Report on a Publicly Notified Resource Consent Application

(Section 42A)

Application Reference:	RMA/2023/3243
Applicant:	Christchurch City Council
Site address:	South New Brighton Park and Southshore Spit estuarine margins and adjoining land
Legal Description:	Various (see Appendix 1)
Proposal:	South New Brighton Park and Southshore inundation protection works and coastal erosion protection works
Zoning:	District Plan: Open Space Community Parks Zone Open Space Coastal Zone Specific Purpose (Flat Land Recovery) Zone Residential Suburban Zone Specific Purpose (Ōtākaro Avon River Corridor) Zone (stockpile site only) City Plan: Conservation 1A Living 1
Overlays and map notations:	High Flood Hazard Management Area Fixed Minimum Floor overlay within a Flood Management Area Flood Management Area Liquefaction Management Area Coastal Environment Avon Heathcote Estuary/Te Ihutai and Environs Site of Ecological Significance (Site reference SES/LP/14 in Appendix 9.1.6.1) ONF36.0 Outstanding Natural Feature - Te Ihutai / Avon-Heathcote Estuary (ONF-36:0, as defined in Appendix 9.2.9.1.1(a)(viii)) Area of at least High Natural Character in the Coastal Environment - Avon-Heathcote Estuary/ Te

Figure 4: On right, area of connection to be retained as a swale or otherwise, green arrow (Source: S Keenan), with map on left showing location of bund within SNBP³⁶.

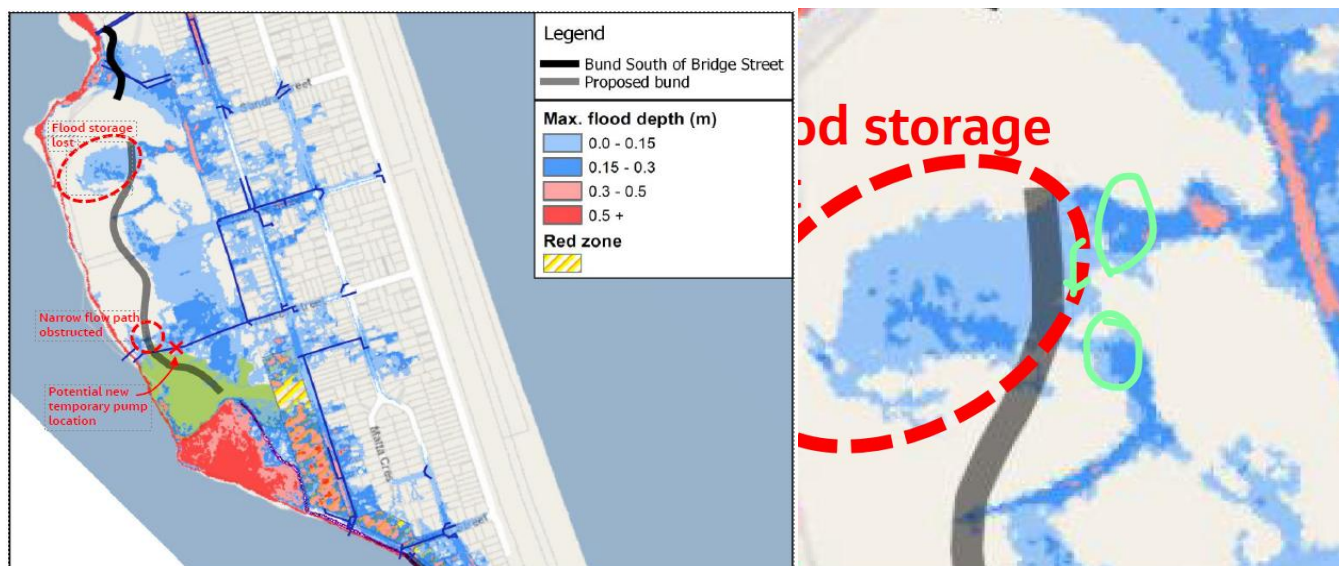
168. Ms Keenan concludes that when considering LiDAR detail, the noted area of floodplain storage loss at the northern end of the proposed works potentially provides a critical connection through from the Estuary Road residential area to lower lying land to the south, especially following the severing of the overland flow to the north of this by the previous bund works³⁵.

169. Ms Keenan advises that the bund detail in this area will need to ensure that connection remains on the eastern side of this (whether as a swale formation or just formed level land) at no greater than 10.9m RL, between the circled flood areas in the snip on the right below (see Figure 4).

170. Ms Keenan states:
As long as this flow path is maintained, I consider that the loss of the flood storage will not have unacceptable effects on flooding patterns.

171. The Applicant has confirmed in their RFI Response dated 19 February 2025 that the connection will be maintained and that this will be further developed during the detailed design process.
